Square Fashions Ltd

Rokeyapur, Jamirdia, Habir Bari, Valuka, Mymensingh, Bangladesh
(+24.29540N,90.38831E)
29th June 2014

Observations

Building 1 - Cracking to load-bearing masonry wall

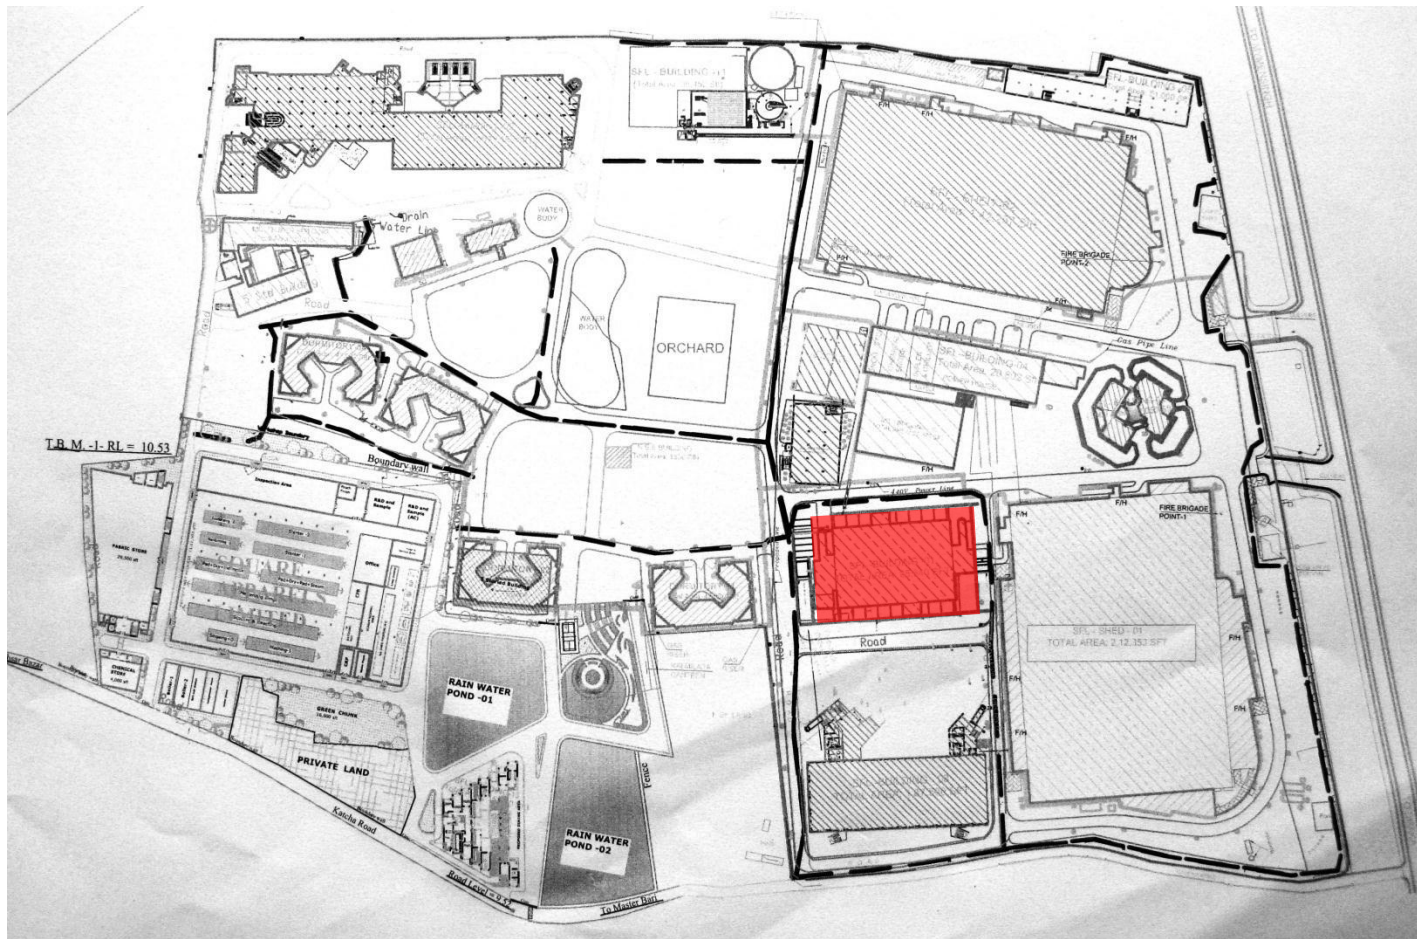
Cracking was observed to a load bearing masonry wall supporting a lintel. The masonry wall is located along the East elevation of Building 1 where the RC stair core meets the steel frame structure. The connection detail between the structures is not clear.

Item No.	Observation	Recommended Action Plan	Recommended Timeline
1	Building 1 - Cracking to load-bearing masonry wall	Building Engineer to review extent of cracking in masonry wall and carry out a design check on this element for the applied loads.	6-weeks
2	Building 1 - Cracking to load-bearing masonry wall	Building Engineer to implement any actions / supervise remedial works to masonry wall as identified following the review.	6-weeks
3	Building 2 - Heavy floor loading and lack of adequate loading plan	Building Engineer to produce a loading plan for each area of the building, with due consideration to column and floor capacity in each area.	6-weeks
4	Building 2 - Heavy floor loading and lack of adequate loading plan	Factory Management to ensure loading plan is implemented and actively managed.	6-weeks
5	Building 2 - Heavy floor loading and lack of adequate loading plan	Continue to implement loading plan	6-months

B2 - Stability Bracing

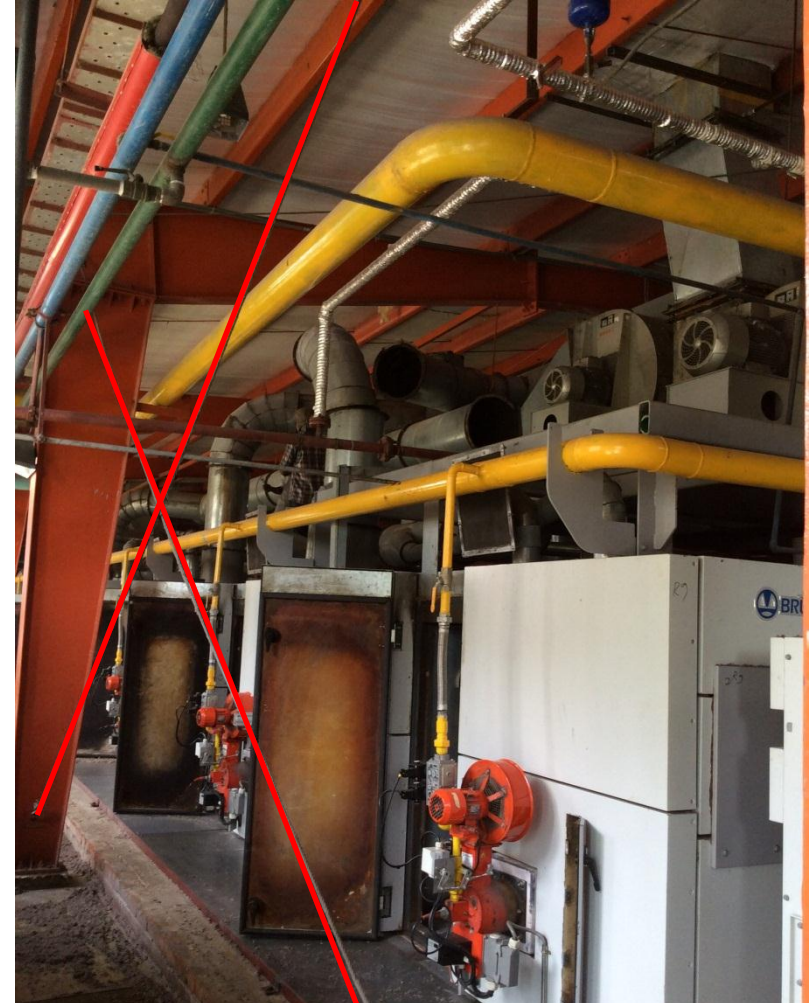
Vertical bracing is missing to the steel frame structure at Ground Floor level and, where provided, bracing is loose and therefore ineffective to the steel structures at both Ground and 3rd Floor levels. Wind posts are missing to the gable end at 3rd Floor level.

Missing vertical bracing in single storey shed

Loose bracing in single storey shed

6	Building 2 - Lack of stability members to steel roof structures	Building Engineer to review stability design and stability systems provided to each area of Building 2 and prepare a schedule of necessary remedial works.	6-weeks
7	Building 2 - Lack of stability members to steel roof structures	Stability member remedial works to be carried out.	6-months

Buildings 3, 5 and 7 - Heavy loading to suspended floors and lack of adequate loading plans

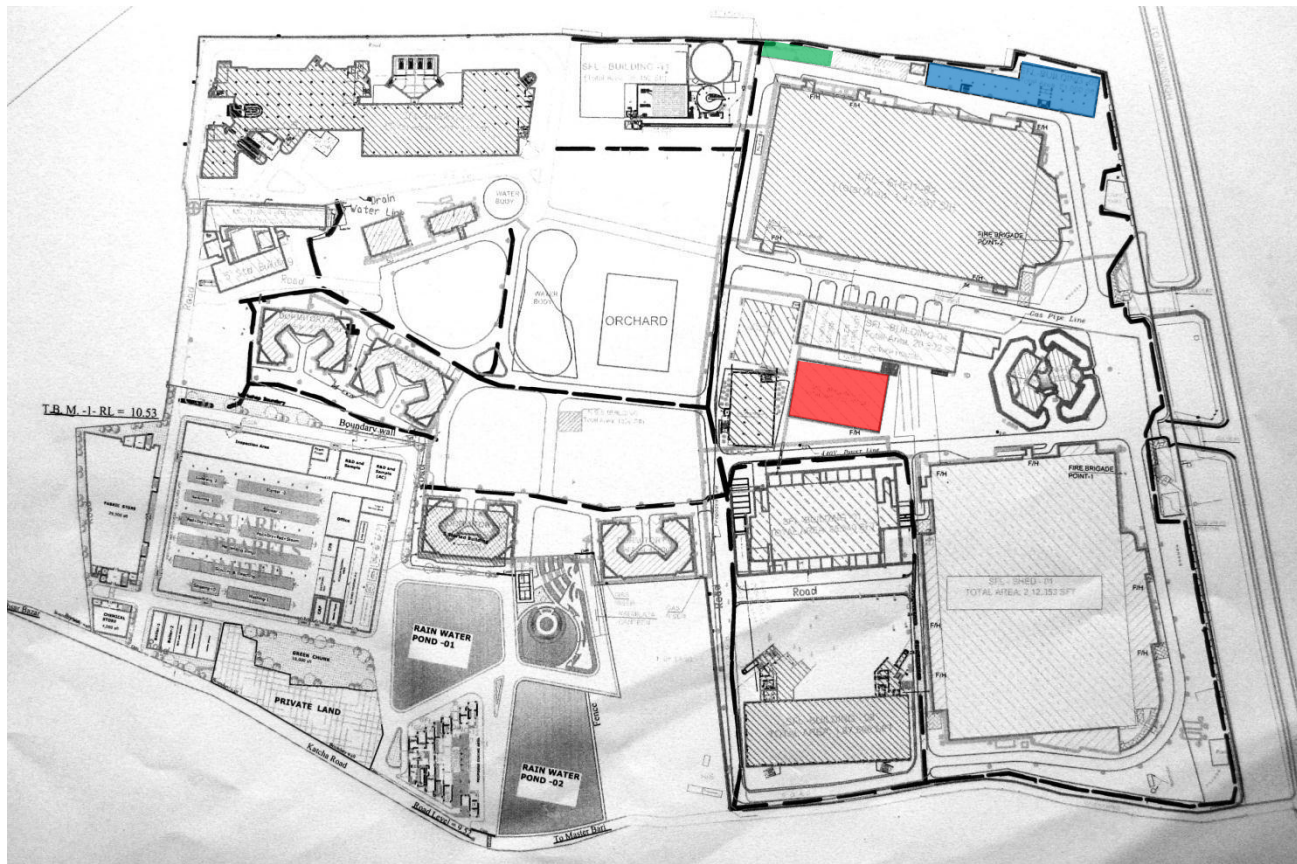
Heavy loading was observed to Buildings 3, 5 and 7. While these buildings appear to have been designed as storage buildings, the loading on the floors does not appear to be managed. While some loading plans were provided, these appeared to be based on loadings observed at the factory at a particular time; it is not clear whether the loads represent the maximum allowable floor loading.

Item No.	Observation	Recommended Action Plan	Recommended Timeline
15	Buildings 3, 5 and 7 - Heavy loading to suspended floors and lack of adequate loading plans	Building Engineer to produce a loading plan for each of the buildings, with due consideration to column and floor capacity.	6-weeks
16	Buildings 3, 5 and 7 - Heavy loading to suspended floors and lack of adequate loading plans	Factory Management to ensure loading plan is implemented and actively managed.	6-weeks
17	Buildings 3, 5 and 7 - Heavy loading to suspended floors and lack of adequate loading plans	Continue to implement loading plan	6-months
18	Shed 3 appears to be non-engineered	Building Engineer to review the design of Shed 3, and to confirm, by calculations, its ability to withstand wind loading pressure, suction and uplift forces, with special emphasis on connections and bracing.	6-weeks
19	Shed 3 appears to be non-engineered	Building Engineer to implement any actions / supervise any remedial works as identified following the review.	6-months

Shed 3 - appears to be non-engineered

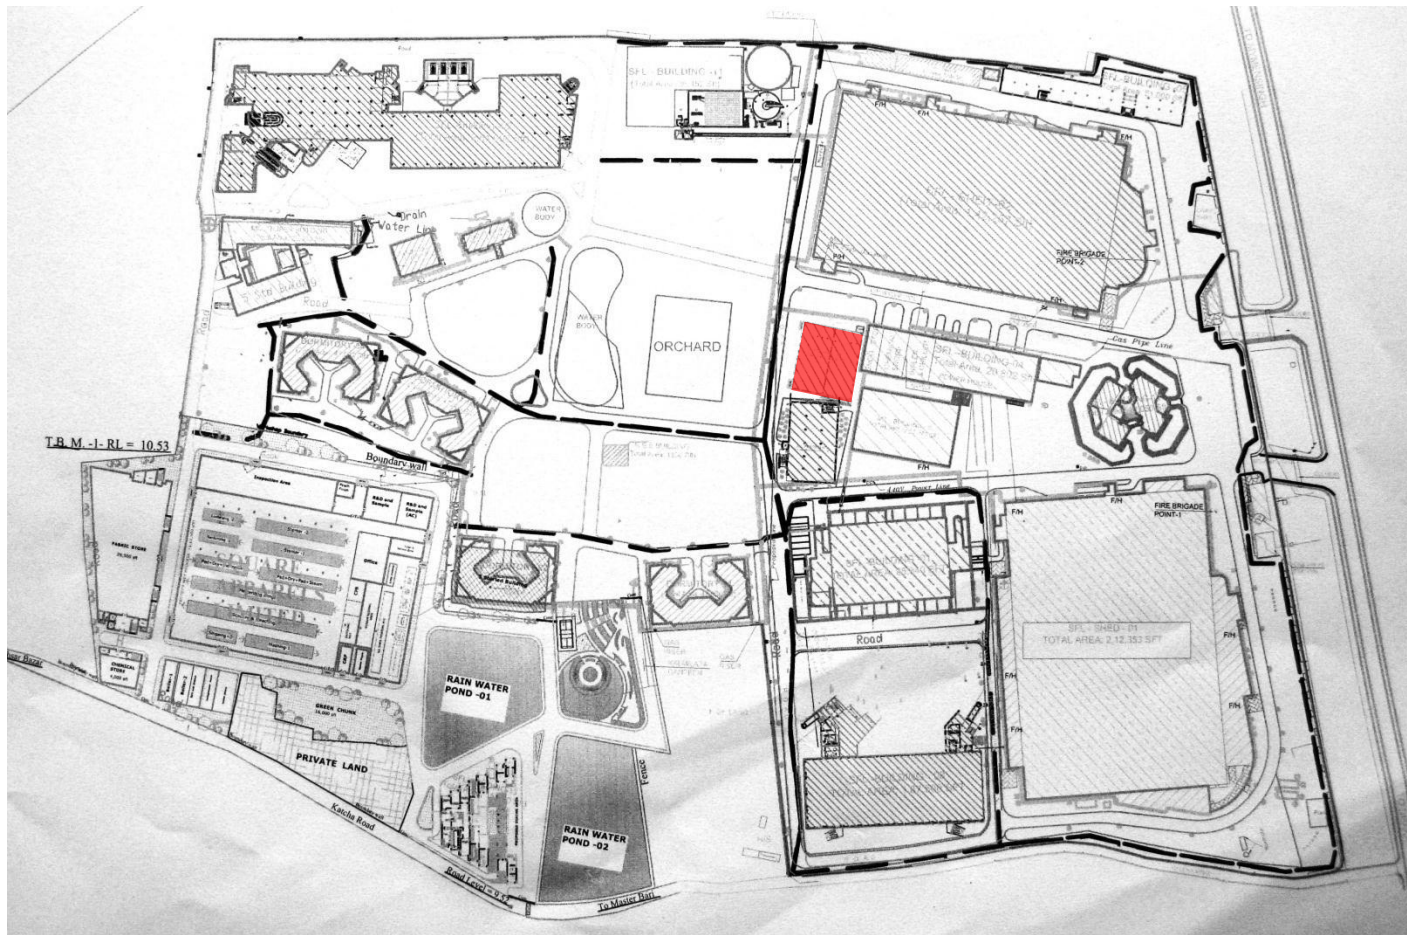
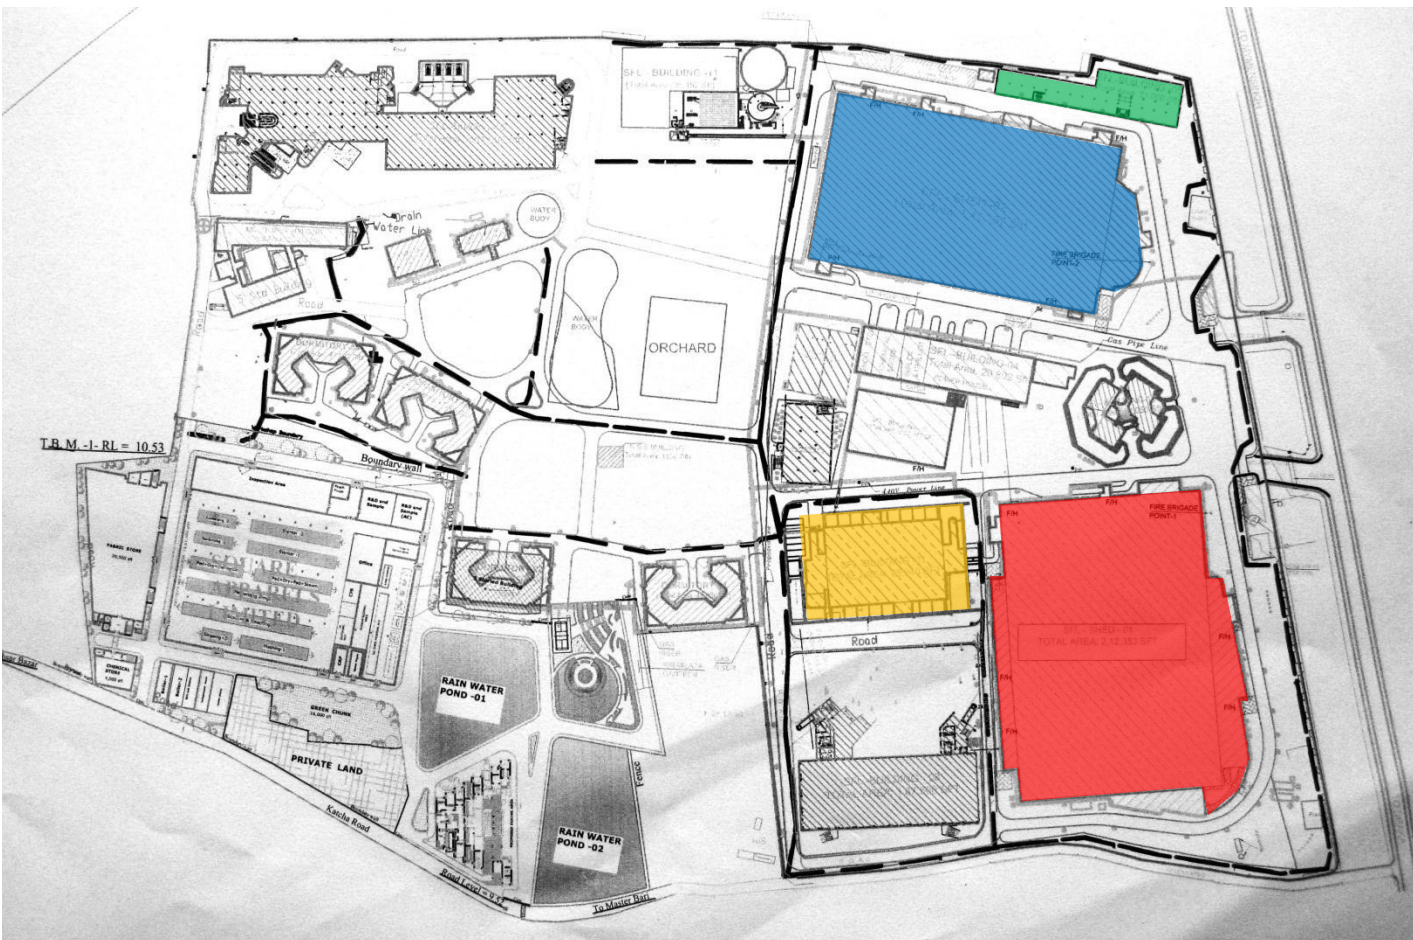
Shed 3 appears to be non-engineered. The prefabricated roof trusses appear to be supported on a combination of masonry walls and RC-encased steel posts, the connections to which are unclear. The lateral stability system of the building is not clear. The design documents are incomplete.

Lateral stability system unclear – no apparent bracing system

Connection details between trusses and support structure are not clear

Wind posts missing to gable end

Substandard connection details

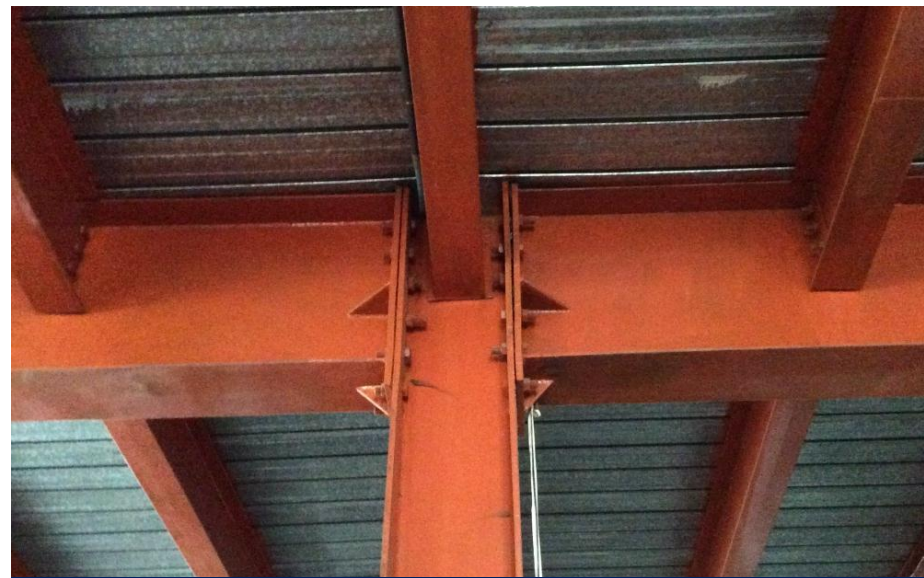
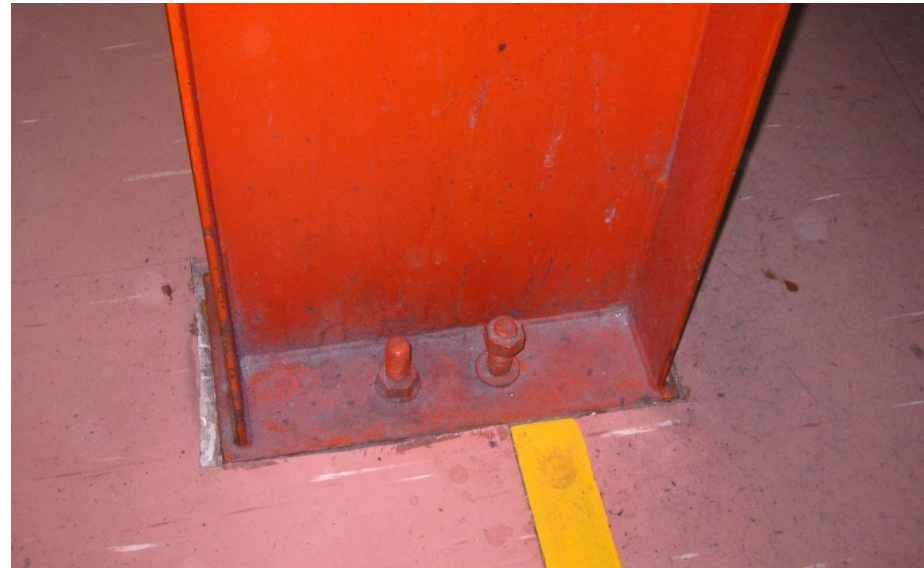
Steel connection details in a number of buildings were observed to be substandard, including inadequate bearing / opening up of end / splice plates, missing or inadequately installed bolts, over-sized bolt-holes, etc.

Building 1 – RC column to steel beam connection

Building 5 – Minimal bearing of end plates

Building 5 – Minimal bearing of end plates

Shed 1 – Loose nuts to bolts

Item No.	Observation	Recommended Action Plan	Recommended Timeline
21	Shed 1 and Buildings 1 & 5 - substandard connection details	Building Engineer to review all connection details to Sheds 1 and Buildings 1 and 5, and to prepare a schedule of actions / remedial works, as required.	6-weeks
22	Shed 1 and Buildings 1 & 5 - substandard connection details	Building Engineer to implement any actions / supervise any remedial works as identified following the review.	6-months
23	Sheds 1 and 2 - Cracking, ponding and water damage to perimeter RC roof slabs	Building Engineer to review extent of cracking, ponding and water damage to roofs and to prepare a schedule of remedial works, as required.	6-weeks
24	Sheds 1 and 2 - Cracking, ponding and water damage to perimeter RC roof slabs	Building Engineer to implement actions / supervise any remedial works as identified following the review.	6-months
25	Missing original documentation and inaccuracies in documentation provided	Building Engineer to check, collect information and produce accurate and fully complete as-built documentation.	6-months

Sheds 1 and 2 - Cracking, ponding and water damage to perimeter RC roof slabs

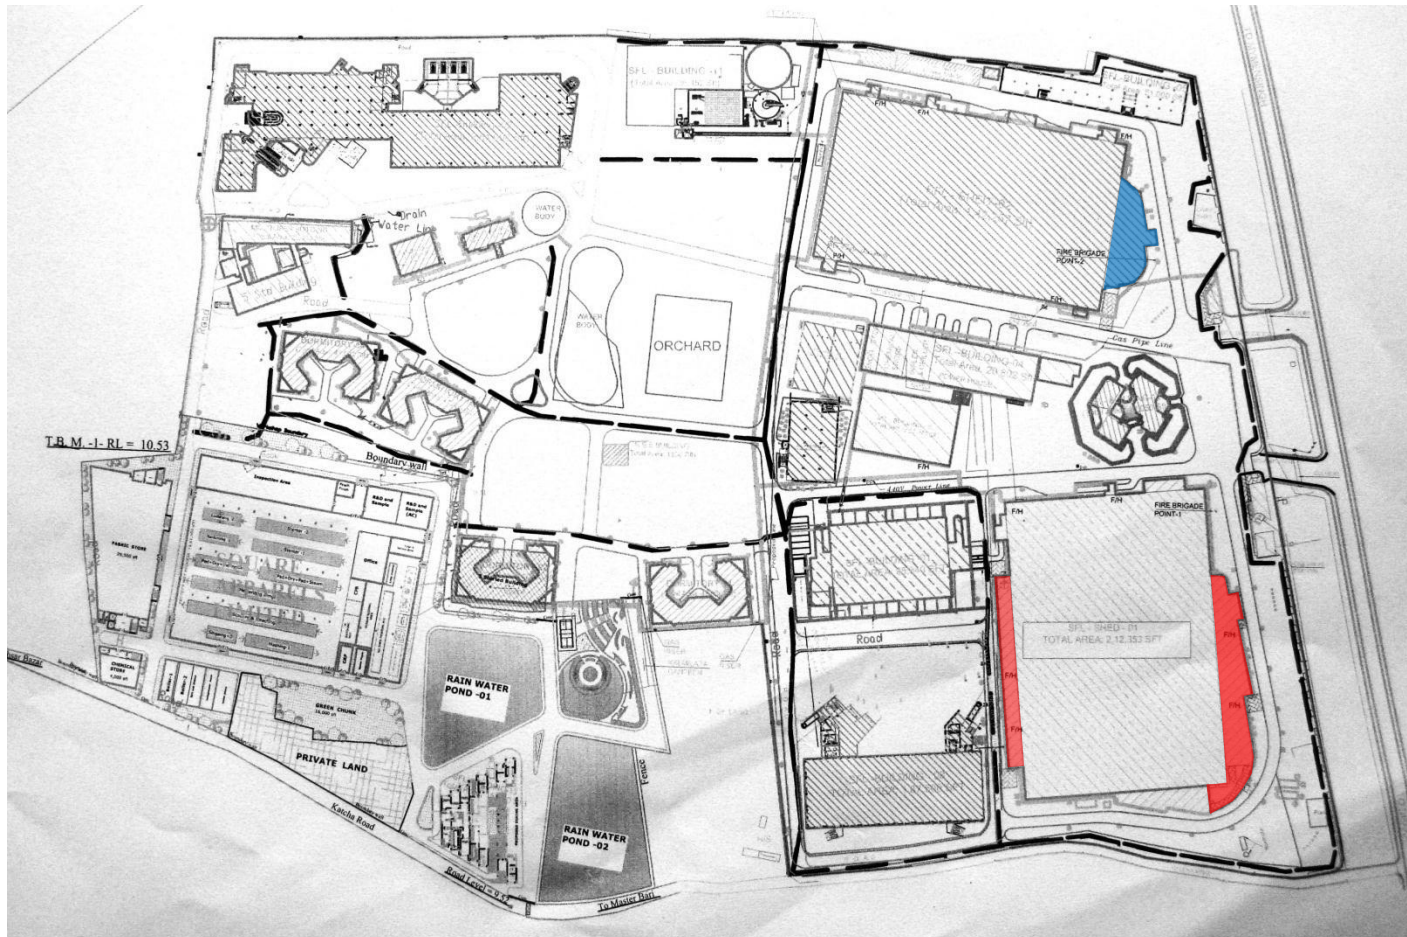
Cracking, ponding and water damage was observed to the roof slabs of the perimeter single-storey RC structures to Sheds 1 and 2.

Shed 1 – Cracking to roof slab

Shed 1 – Water ponding on roof slab

Shed 1 – Water damage to roof slab

Documentation

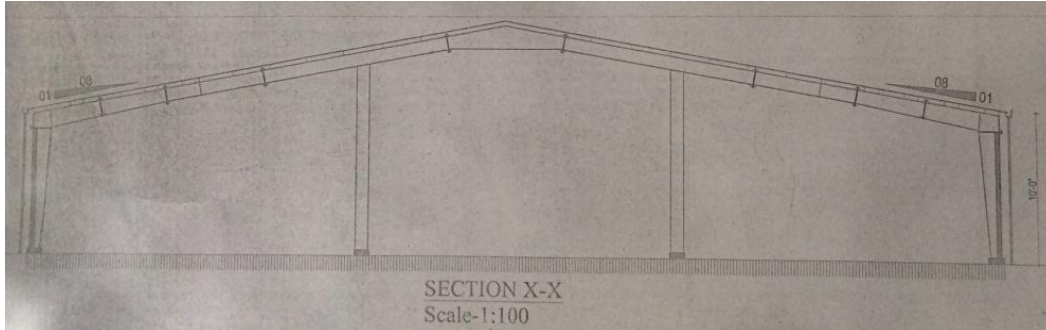
Permit drawings were not provided for review. Furthermore, there are a number of inconsistencies between the documents provided and the constructed buildings, particularly with the architectural drawings.

Shed 3 – Architectural section does not match constructed building

Building 5 – Staircase not shown on drawings
